Sent: 1/04/2020 11:51:50 AM Subject: DA2019/1522 - 41 to 43 Beach Rd Collaroy Attachments: 41-43 Beach RD ISSUED.pdf;

RE: DA Application number DA2019/1522 – 41 to 43 Beach Road Collaroy

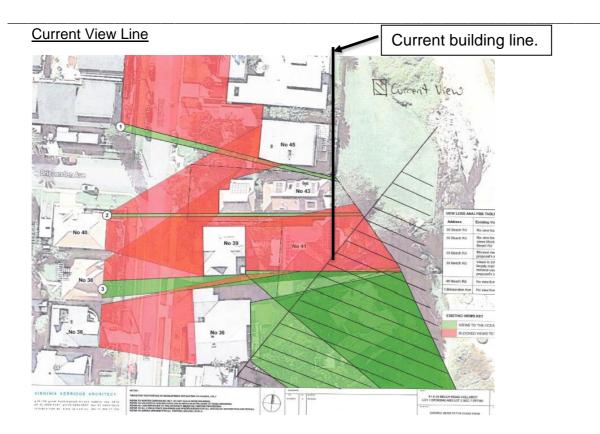
By way of background, we moved to the location due to the significant amounts of vegetation and nature outlook of the landscape in the area. The rolling nature of the headland had been well preserved with the existing dwellings compassionate to its location. We are concerned that the location of the bulk of the development along the southern boundary will totally remove that natural landscape and replace it with a 2-3 story building.

Photo 1.

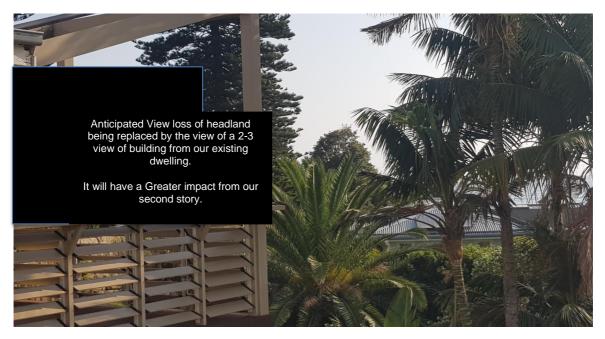
The analysis of view loss within the application does not take into account the excessive scale of this development. Views of vegetation and headland are being replaced by views of a massive concrete and glass structure, decks and privacy screens.

The development totally removes our current view and replaces it with a 2 to 3 story building along the length of its southern boundary. The application does not take into account the impact on the view from 33 Beach Rd across the headland.

The current dwellings on the site maintain an alignment with their neighbouring properties to the north that provides a consistent building line. What is the reason for the building line to be changed in this case from its current alignment?
